Applicant's Response to  
Minute 2 of the Expert Panel  
Further Information Request  
Ayrburn Screen Hub  
FTAA-2508-1093

(18 November 2025)

### Engineered Batter Stability Memo Ayrburn Screen Hub, Arrowtown

To: Lauren Christie, Winton Date: 13/11/2025  
From: Bronwyn Rhynd, Environmental Engineer CC:  
Reviewed: CKL Ref: A20254  
Re: Ayrburn Screen Hub FTAA-2508-1093 - RFI-Stormwater matters

Figure 1: Earthworks plan from Patersons Engineering Report dated 18.7.25 – Engineered fill batter under review as circled in dashed brown line.

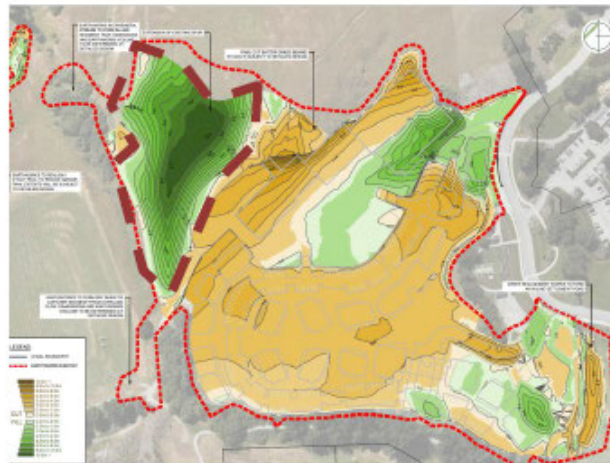
**Item 3c** - *"Confirmation from the project engineers of the maximum gradient of the proposed constructed 'spur' on the north western side of the proposed buildings, engineering advice as to whether as a consequence of that maximum gradient some type of retaining structure will likely be required, and if so, what type of retaining structure that will be and what it will look like"*

Within the GeoSolve geotechnical report (ref: 150098.11, dated 25/06/2025) for this area an engineered fill batter slope of up to a maximum of 3H:1V was recommended however the earthworks plans indicate an up to a maximum of 2H:1V slope is proposed. To ensure permanent stability of the slope where 3H:1V is exceeded it is proposed to incorporate geogrid reinforcement within the engineered fill. GeoSolve propose to complete the specific design of the geogrid reinforcement during the detailed design phase of the project.

The geogrid reinforcement is placed within the fill and is not visible on the final slope face. It is therefore noted that the proposed planting, which we understand will comprise mixed native shrub and tree plantings (as detailed within the Ayrburn Design Report, Appendix 7), remains feasible with the inclusion of the proposed geogrid reinforcement.

To confirm, there is no change from a visual perspective or earthworks design/shaping perspective as shown on the Engineering Plans within Appendix 20.

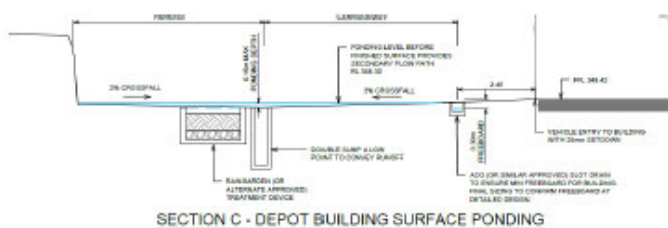
*(d) Confirmation that the revised contouring of the site to accommodate the constructed spur has been incorporated in flood modelling of the site (with a cross reference to where this is discussed in the application materials), and if not, revised flood modelling doing so (and assessment of any incremental effects)*

The proposed plan associated with the stormwater management and flood assessment is presented in the Stormwater Management Plan (SMP) within Section 3. The constructed spur is highlighted in Figure 2. Furthermore, within the flood model the proposed condition includes the constructed spur as illustrated in Section 10.1 and Figure 14. Sheets 410 – 455 of the Engineering Drawings by Patersons (Appendix 20) provide further information on catchment plans and stormwater design.

Therefore, it is confirmed that the constructed spur has been incorporated in the flood modelling of the proposed site.

### Consent Condition Wiring Diagram: QLDC conditions

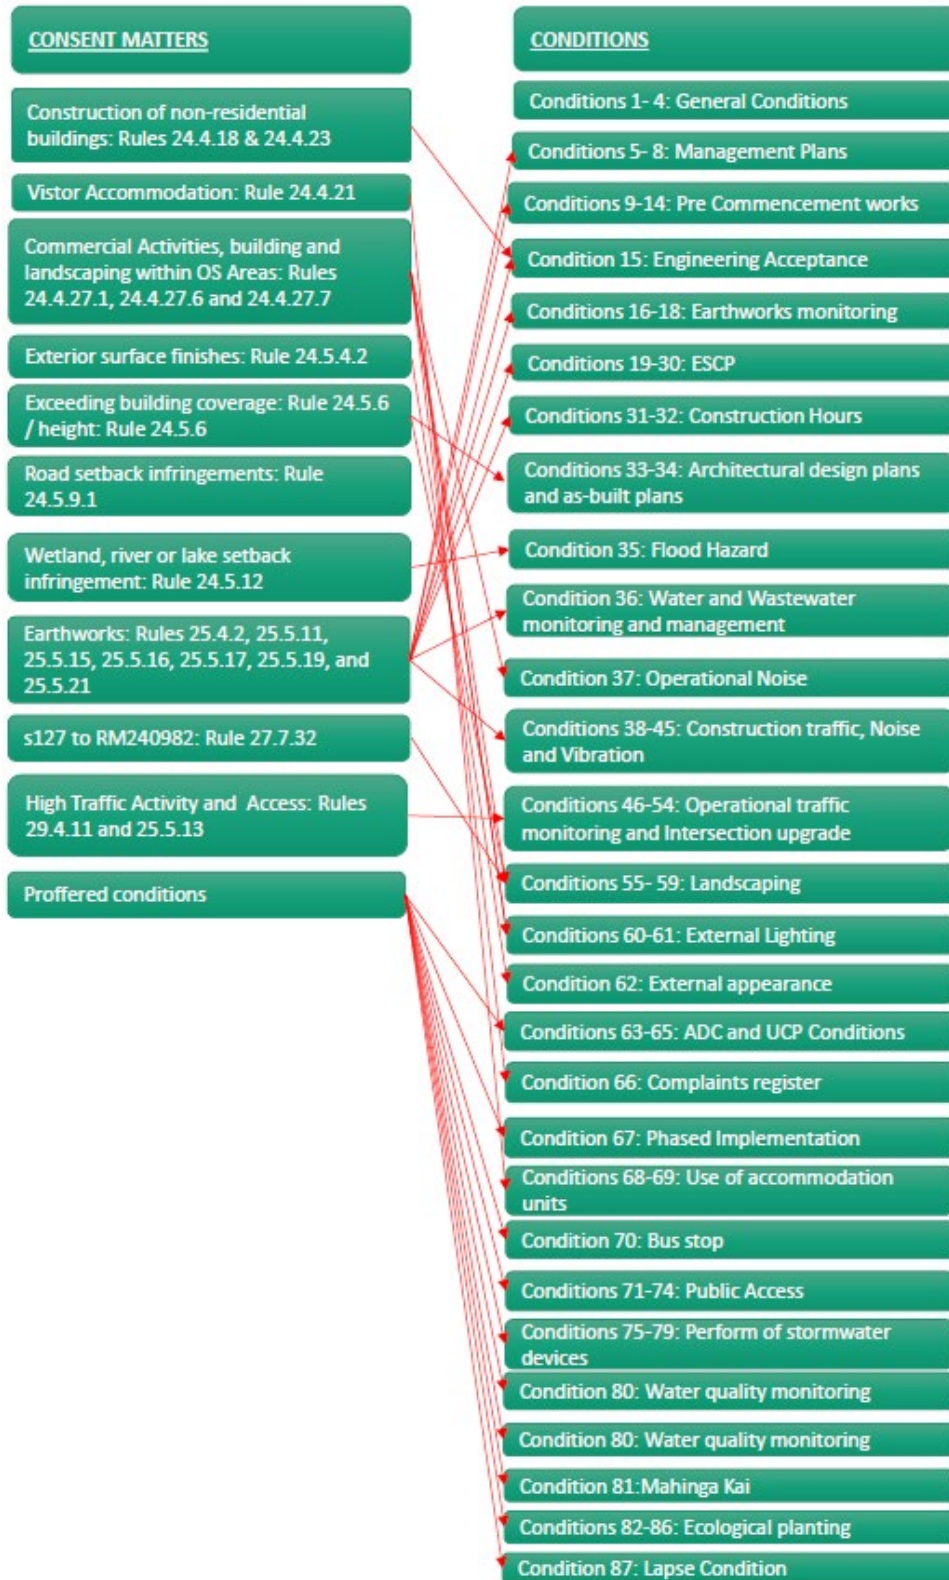
12. The flow chart/wiring diagram requested by the Panel is contained in Schedule D1 (QLDC conditions) and Schedule D2 (ORC conditions) to this Memorandum.
